Re: Turners Falls Hydroelectric Project (FERC No. 1889), FirstLight MA Hydro LLC,
Northfield Mountain Pumped Storage Project (FERC No. 2485), Northfield Mountain LLC,
Response to FERC Additional Information Requests

Turners Falls Project- Response to Additional Information Requests

Northfield Mountain Project- Response to Additional Information Request

Figure AIR 4-1: Location of Flow Sources above Station No. 1

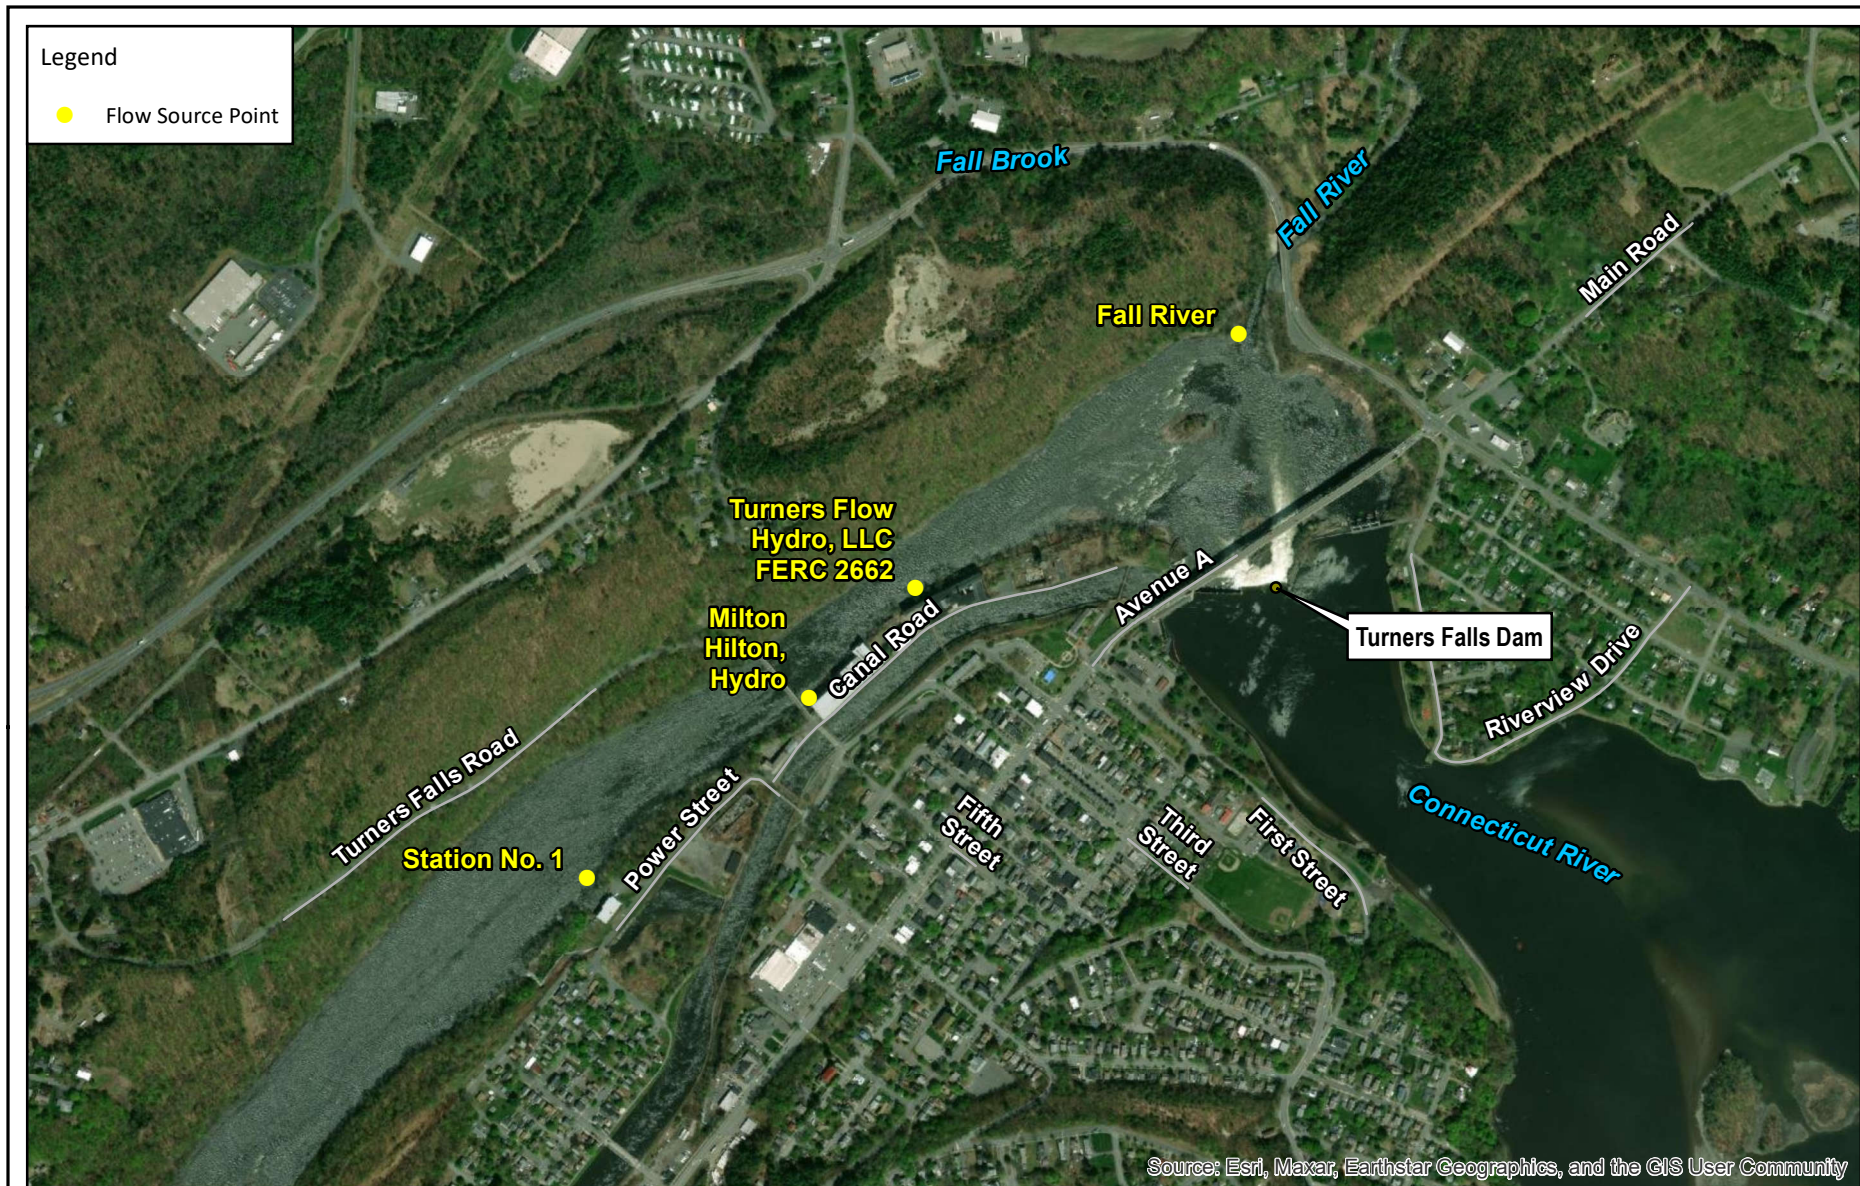
On page A-4 of Appendix A, FirstLight states: “If the Station No. 1 units are used to maintain the Total Minimum Bypass Flow below Station No. 1, and if some or all of the Station No. 1 units become inoperable, the balance of the flow needed to maintain the Total Bypass flow below Station No. 1 will be provided from either the Turners Falls Dam Minimum Flow (dam or canal gate), Fall River, Turners Falls Hydro, LLC or Milton Hilton, LLC.” Flow releases from the Fall River, Turners Falls Hydro, LLC, and Milton Hilton, LLC appear to be outside the control of FirstLight, and it is unclear how FirstLight would use flow releases from these sources to provide the proposed minimum flow, in the event the Station No. 1 units become inoperable. For each source, please specify: (1) the location of the flow release; (2) any procedures that FirstLight would use to measure and monitor changes in the flow release (including the type, location, and accuracy of any monitoring equipment and gages); and (3) any written agreements between FirstLight and Turners Falls Hydro, LLC or Milton Hilton, LLC, to release minimum flows from the locations specified in item 1 above. In addition, please specify any procedures that FirstLight would use to adjust flows from other sources (i.e., the Turners Falls Dam), as needed to maintain compliance with the proposed minimum flow.

FirstLight included the option of maintaining the Total Minimum Bypass Flow below Station No. 1 not only from Station No. 1 discharge or Turners Falls Dam spill, but from the Fall River or discharges from the Turners Falls Hydro, LLC⁶ and Milton Hilton, LLC. [Figure AIR4-1](#) shows the location of the Fall River confluence with the Connecticut River, and the Turners Falls Hydro, LLC and Milton Hilton, LLC discharge locations. FirstLight does not have specific details on how it will measure and monitor changes in flow at these three locations. At this juncture, FirstLight proposes to maintain the Total Minimum Bypass Flow below Station No. 1 via Station No. 1 generation and/or Turners Falls Dam discharge. FirstLight will conduct further evaluations to determine if monitoring these sources of flow is feasible and cost effective. FirstLight would also need to consult with the owners of Turners Falls Hydro, LLC and Milton Hilton, LLC to determine how project discharge data could be obtained; there are no current written agreements with these entities to release flow. If FirstLight determines it is feasible to quantify the flow from these three sources in the future it would seek to amend the FERC license accordingly.
